NATIONAL PARK SERVICE
Natural Sounds and Night Skies Division
1201 Oak Ridge Drive, Suite 100
Fort Collins, CO 80525

Subject: Comments on the noise analysis in the USFS South Fowl Lake Snowmobile Access EIS

Date: August 21, 2012

Figure G-11a: Model Run #11. Alternative 2 Route Noise Impacts Predicted by SPreAD GIS Model, calm wind winds, 13 degrees F.

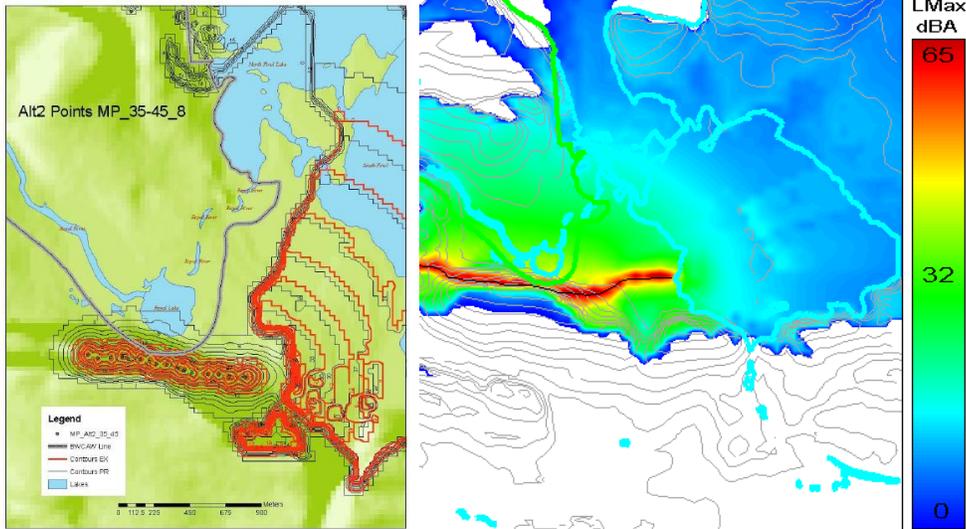
2. SPreAD-GIS may not consider source and receiver height as needed to accurately assess the extent of the source and receiver regions where ground effect occurs. The SPreAD-GIS plots in Appendix G show anomalous predicted levels that are suspicious. By contrast, examples plots are provided below, including Figure G-11a and an alternative geographic noise prediction by NMSim-Nord2000 for Alternative 2.

- b. In Figures G-1 through G-12a, the model calculations appear to incorrectly assume exposed ground and water representative of a summer condition and not a typical Minnesota winter condition when snow covers all ground features, including frozen lake surfaces. This could occur if ground effect was calculated based on National Land Cover Dataset (NLCD) layers.

- c. In Figures G-4a through G-12a (not b), the contours extending across the southern bay of North Fowl Lake extend farther north than would be considered reasonable, even during a summer condition. The presumed reason is an improper calculation of ground effect that greatly overestimates the extent (distance) of ground interaction and/or does not consider the independent ground effects at source and receiver.

- d. In Figures G-4a through G-12a (not b), the contours extend south with little or no attenuation into a sheltered ravine (forming a thumb) at the lower southeast corner of the plot. There is insufficient attenuation due to the diffractive loss expected as sound propagates around the nearby ridges, approximately 900 meters to the southeast of the easternmost noise source location. The presumed reason is an improper calculation of terrain screening that does not adequately consider acoustically relevant terrain geometry such as multiple barriers, lateral attenuation around ridges, and/or complex ground profiles such as depressions and ravines although NPS has not had time to rule out other possible explanations

- e. In Figures G-4a through G-12a (not b), there is a predicted rapid increase in sound levels with increasing distance from the source, resulting in an approximate 60 meter wide band of contours that extends from 450 meters north of the easternmost source an additional 2000 meters north and even across water, where there are no significant sources of attenuation other than conventional spherical spreading and atmospheric losses. Again, the rapid increase in sound levels over 60 meters is extremely suspect, however, NPS has not had the opportunity to explore and rule out other plausible explanations. In Figures G-7a through G-9a (not b), the displayed contours north of Royal Lake are strangely square in shape. NPS has not had the opportunity to identify the cause with any certainty, but this could be due to a number of

- f. In Figures G-1 through G-12a, SPreAD-GIS results show strange jumps and steps which are difficult to physically justify and thereby may reveal potential errors or it could just be a limitation in the resolution. NPS has not had the opportunity to confirm the cause. The SPreAD-GIS and NMSim-Nord2000 example plots below show different sound levels and use a different graphical approach for display of noise levels, but they can be compared in terms of expected attenuation over distance. Both are set up to show noise levels only down to 0 dB. The plots highlight some of the aforementioned anomalies of the SPreAD-GIS results at 500 Hz. In Figure G-11a (shown on left), black noise contours surrounding expected Alt 2 snowmobile noise source locations drop off too rapidly from the reported 66 dB (at 50 feet) to 0 dB over Royal Lake, approximately 275 meters north of the noise source. NMSim-Nord2000 (shown on right) predicts a level of approximately 39 dBA over Royal Lake, at roughly equivalent distances.

Approximately 1800 meters to the north (and 1200 meters north of Royal Lake), SPreAD-GIS predicts a rapid increase in sound levels to 15 dB. NMSim-Nord2000 does not show any increase and instead predicts a level of 17 dBA, 22 decibels below the Royal Lake value of 37 dBA. A 15 dB increase where an approximate 20 dB of attenuation is expected indicates that SPreAD-GIS values could be off by substantial amounts. The reasons for the rise in sound levels with increasing distance are unknown. To the east of the easternmost noise source location, SPreAD-GIS predicts a drop to approximately 12 dB in 250 meters and then a rise to 36 dB 350 meters to the east the source. This rapid rise in sound levels continues in an apparent 60 meter wide band 2000 meters to the north, described in point (e) above. Such a rapid change in sound levels is highly questionable but NPS has not had the opportunity to further explore or rule out any explanations. In general, NMSim-Nord2000 does not show an increase of sound levels to the east and northeast of the proposed Alternative 2 trail. The results produced by NMSim-Nord2000 do not exhibit the same physical anomalies produced by SPreAD-GIS.

Comment [A11]: We understand from this comment that the maps from SPreAD-GIS show anomalous results but the NPS is not saying that the anomalies invalidate the SPreAD-GIS model; rather the NPS has not determined the cause of the anomalies. This was also discussed in the NPS report of August 2012. Rather than further investigate the anomalies, the SNF chose to have the NPS run the NMSim model to improve the technical accuracy of the modeling.
